State of New Mexico
Energy, Minerals and Natural Resources

Form C-103
Revised July 18, 2013

WELL API NO. 30-021-20114
5. Indicate Type of Lease STATE <input type="checkbox"/> FEE <input type="checkbox"/>
6. State Oil & Gas Lease No.
7. Lease Name or Unit Agreement Name Bravo Dome Carbon Dioxide Gas Unit
8. Well Number 331
9. OGRID Number 16696
10. Pool name or Wildcat Bravo Dome Carbon Dioxide Gas Unit 640

OXY USA INC respectfully requests a five year Temporarily Abandon Status Extension from the current TA expiration date of 9/30/2020. Plan forward is as follows:

Proposed Wellbore
Bravo Dome CDGU #331
30-021-20114-0000
Harding

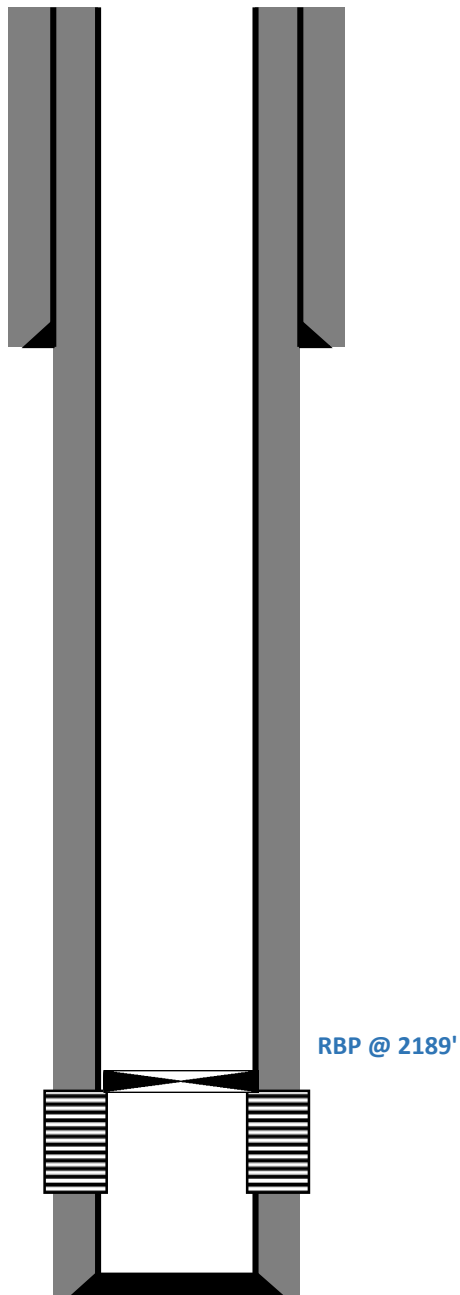
1. Set retrievable bridge plug ~50' above top perf
2. Notify NMOCD of casing integrity test 24hours in advance to witness test
3. RU pump truck, circulate well with treated water, pressure test casing to 500 psi for 30 min

Created By	Condition	Condition Date
mkuehling	NMOCD witness required on all testing. Northwest bradenhead test required prior to MIT - performed day of MIT - all valves need to be dug out and plumbed to surface - do not bury till after testing - chart recorder with 1000 lb spring - 1 hour clock - chart should match spring and clock	9/10/2021
